FLN-2007-018

Markup of Section 1-6 of GESTAR II US Supplement

S.1 Introduction

**Figure S-5 Scenario 2 Krypton TEDE with Respect to Charcoal Hold Up
Utilizing AST Methodology**

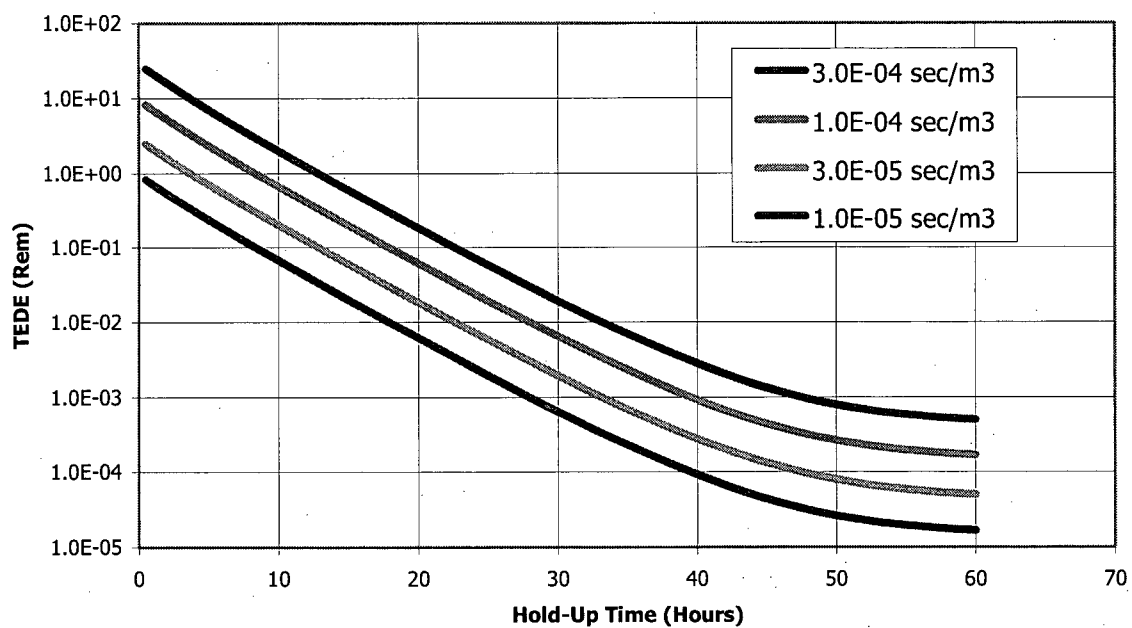
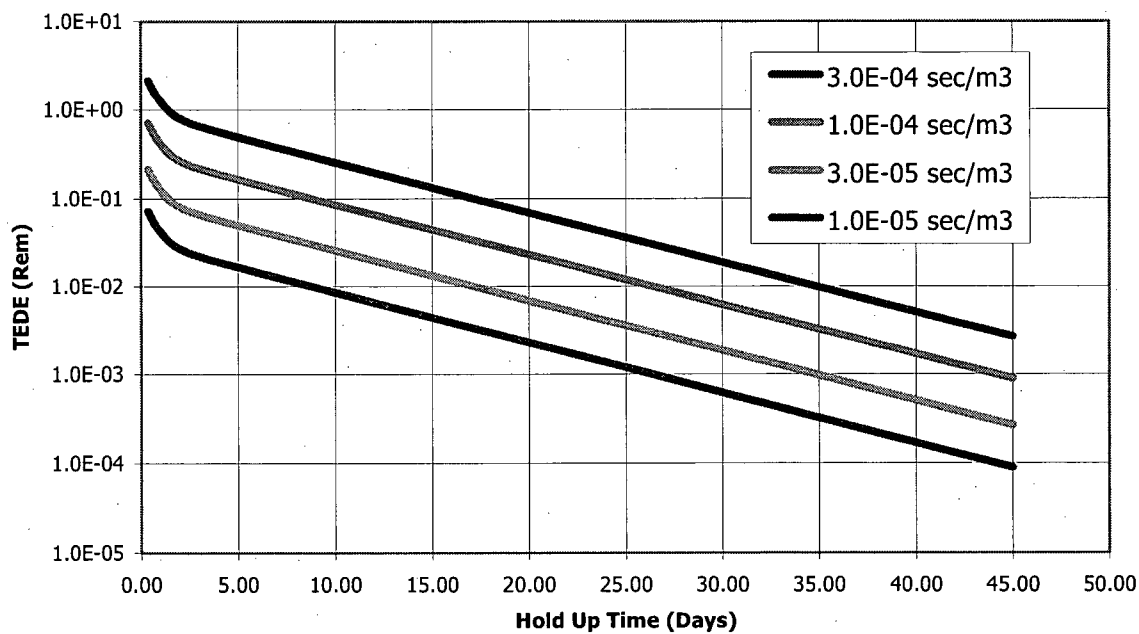
In a similar fashion, plants with a 10CFR50.67 radiological basis will use Figures S-5 and S-6 to confirm the applicability of the generic analysis. Using the plant specific parameters, the plant must confirm that the plant specific result is less than the 2.5 Rem TEDE dose limit.
